Access Audit Site Report

Lake Brownwood State Park
200 State Hwy Park Rd 15
Brownwood, TX 76801
Accessibility Evaluation
Inspection Date: 02/28/2022
Inspectors: Tanya Scheibe

Prepared By
WT Group

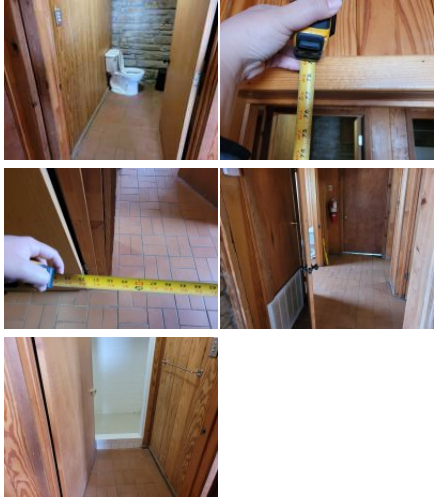
Finding Number	Area Description	Lat/Long	Finding	As Built	Recommendation	Citation	Photos	Figure
458	Beach Lodge : Beach Lodge - Public Space	[31.8604476 , -99.019027 9]	The operable part is positioned too high for either a side or front approach. Where a clear floor or ground space allows a parallel approach to an element and the side reach is unobstructed, the high side reach shall be 48 inches maximum and the low side reach shall be 15 inches minimum above the finish floor or ground. Where a forward reach is unobstructed, the high forward reach shall be 48 inches maximum and the low forward reach shall be 15 inches minimum above the finish floor or ground.	light switch and thermostat 62" AFF in back hall	Remount operable parts to be in reach range of 15" min to 48" max	2015 ABAAS Section: 308.1 2012 TAS Section: 308.1 2010 ADAS Section: 308.1		
459	Beach Lodge : Beach Lodge - Public Space	[31.8604616 , -99.019035 7]	The operable part is positioned too high for either a side or front approach. Where a clear floor or ground space allows a parallel approach to an element and the side reach is unobstructed, the high side reach shall be 48 inches maximum and the low side reach shall be 15 inches minimum above the finish floor or ground. Where a forward reach is unobstructed, the high forward reach shall be 48 inches maximum and the low forward reach shall be 15 inches minimum above the finish floor or ground.	living/dining- light switch 60" AFF	Remount operable parts to be in reach range of 15" min to 48" max	2015 ABAAS Section: 308.1 2012 TAS Section: 308.1 2010 ADAS Section: 308.1

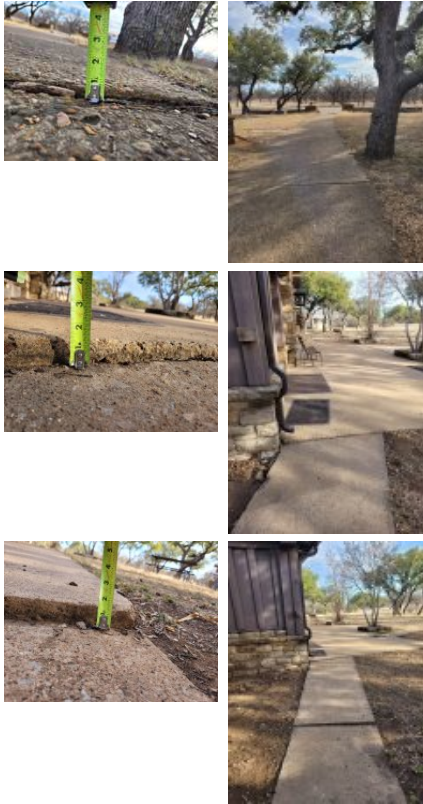
Finding Number	Area Description	Lat/Long	Finding	As Built	Recommendation	Citation	Photos	Figure
483	Beach Lodge : Beach Lodge - Restroom	[31.8605049 , -99.019074 6]	The restroom sign does not comply with one or more applicable requirements for the location, height, and properties of the sign.	restrooms lack signage	Acquire and mount signage, including Braille and raised lettering mounted on wall, latch side of door, 48" to baseline of lowest character and 60" to baseline of highest character.	2015 ABAAS Section: F216.2, 703.1, 703.2, 703.5, 703.6 2012 TAS Section: 216.2, 703.1, 703.2, 703.5, 703.6 2010 ADAS Section: 216.2, 703.1, 703.2, 703.5, 703.6		
484	Beach Lodge : Beach Lodge - Restroom	[31.860489, -99.019034 3]	There are no accessible bathing or shower facilities. Where facilities for bathing are provided for the public, clients or employees, including showers or bathtubs, at least one shower or bathtub and support facilities such as lockers, and not less than 1 percent of all facilities, shall be accessible.	lacks accessible shower	Provide an accessible shoer in beach lodge	2015 ABAAS Section: F213.3.6 2012 TAS Section: 213.3.6 2010 ADAS Section: 213.3.6

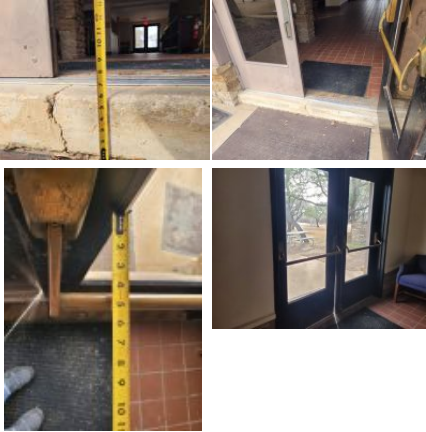
Finding Number	Area Description	Lat/Long	Finding	As Built	Recommendation	Citation	Photos	Figure
497	Group Rec Bldg: Rec Bldg- Kitchen	[31.8593476 , -99.017784 4]	The top rim of the sink is too high. All lavatories/sinks that are designated to be accessible shall be a minimum 17 inches in horizontal depth and mounted with the rim or counter edge no higher than 34 inches above the finished floor.	sink 36" AFF	Lower sinks to max 34" above the finished floor (AFF) to front of rim.	2015 ABAAS Section: 606.3 2012 TAS Section: 606.3 2010 ADAS Section: 606.3		
498	Group Rec Bldg: Rec Bldg- Kitchen	[31.8593499 , -99.017773 7]	Knee and toe space has not been provided at the sink. Kitchen sinks must be provided with a clear floor space positioned for a forward approach including knee and toe clearance.	sink lacks knee clearance	Remove base cabinet and lower sink height to max 34" aff.	2015 ABAAS Section: 606.2, 804.4 2012 TAS Section: 606.2, 804.4 2010 ADAS Section: 606.2, 804.4

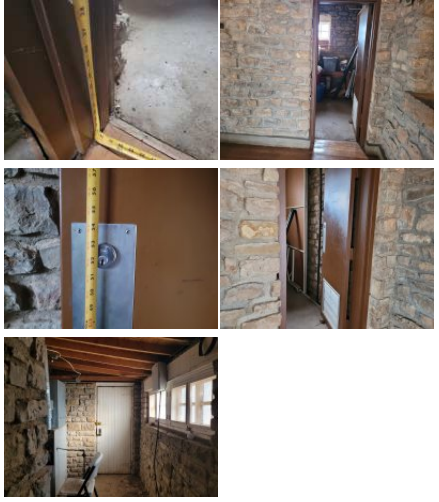
Finding Number	Area Description	Lat/Long	Finding	As Built	Recommendation	Citation	Photos	Figure
506	Group Rec Bldg: Rec Bldg- Main Room	[31.8593408 , -99.017776 4]	The operable part is positioned too high for either a side or front approach. Where a clear floor or ground space allows a parallel approach to an element and the side reach is unobstructed, the high side reach shall be 48 inches maximum and the low side reach shall be 15 inches minimum above the finish floor or ground. Where a forward reach is unobstructed, the high forward reach shall be 48 inches maximum and the low forward reach shall be 15 inches minimum above the finish floor or ground.	outlets 59.5" AFF and 66" AFF, thermostat high	Remount operable parts to be in reach range of 15" min to 48" max	2015 ABAAS Section: 308.1 2012 TAS Section: 308.1 2010 ADAS Section: 308.1

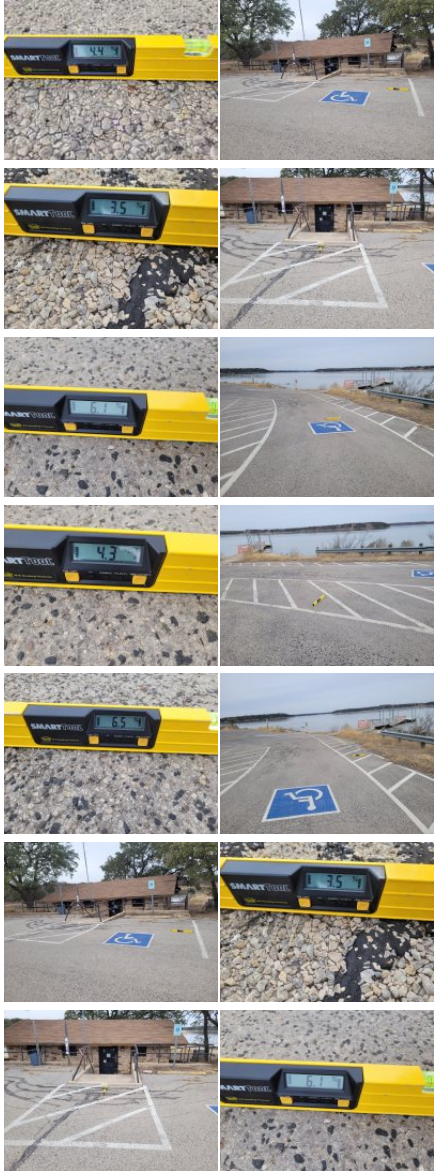
Finding Number	Area Description	Lat/Long	Finding	As Built	Recommendation	Citation	Photos	Figure
556	Loma Vista Lodge : LV - Public Space	[31.8530313 , -99.0151116]	The 30 inches minimum by 48 inches minimum clear floor space required at the operable part is not flat (2% or 1:48 maximum slope) in all directions. Changes in level are not permitted at required clear floor or ground space except that slopes not steeper than 1:48 shall be permitted.	3.7% slope in usable portion of table	Correct or repair slope in CFS to max 2.08%	2015 ABAAS Section: 305.2 2012 TAS Section: 305.2 2010 ADAS Section: 305.2	 	
557	Loma Vista Lodge : LV - Public Space	[31.8530393 , -99.0151451]	There is a gap spaced greater than a 1/2 inch. Openings in floor or ground surfaces shall not allow passage of a sphere more than 1/2 inch diameter. Elongated openings shall be placed so that the long dimension is perpendicular to the dominant direction of travel.	1" gap at LV patio	Correct or fill gaps to be max .5"	2015 ABAAS Section: 302.3 2012 TAS Section: 302.3 2010 ADAS Section: 302.3
